**ISSUE:** Certificate of Appropriateness for revisions to previously approved plans.

**LOCATION:** Old and Historic Alexandria District  
128 North Pitt Street

**STAFF RECOMMENDATION**

## **UPDATE**

**Figure 1: Previously approved rooftop plan on left; current proposal on right. North/Cameron St. is at top.**

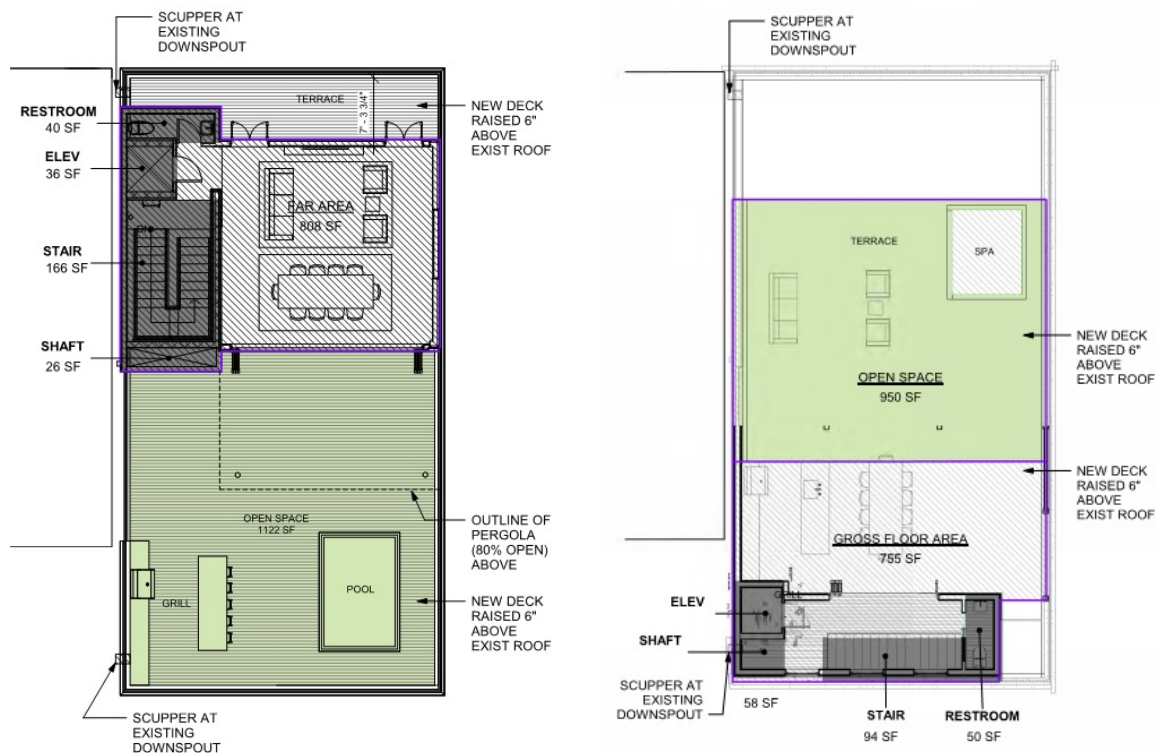
The major change to the previously approved application relates to the rooftop addition. The new plan significantly reduces the size of the approved addition and relocates it to the rear of the building, greatly decreasing its prominence. **Figure 1.** Reducing the size of the rooftop addition by 600 square feet and moving it away from Cameron Street places it more in context with its neighbors and better respects the historic nature of the original building.

As part of the roof project, the applicant proposes using steel cable railings instead of extending the parapet, thus better adhering to the *Design Guidelines* recommendation that “An addition to a

historic building should be clearly distinguishable from the original structure.” Steel cabling would never be confused for an original material while extending the height of the existing brick parapet with matching brick, as previously approved, could lead to confusion as to what part of the building is original and what is new. A chimney on the west side of the roof, barely visible from any right of way, would also be demolished.
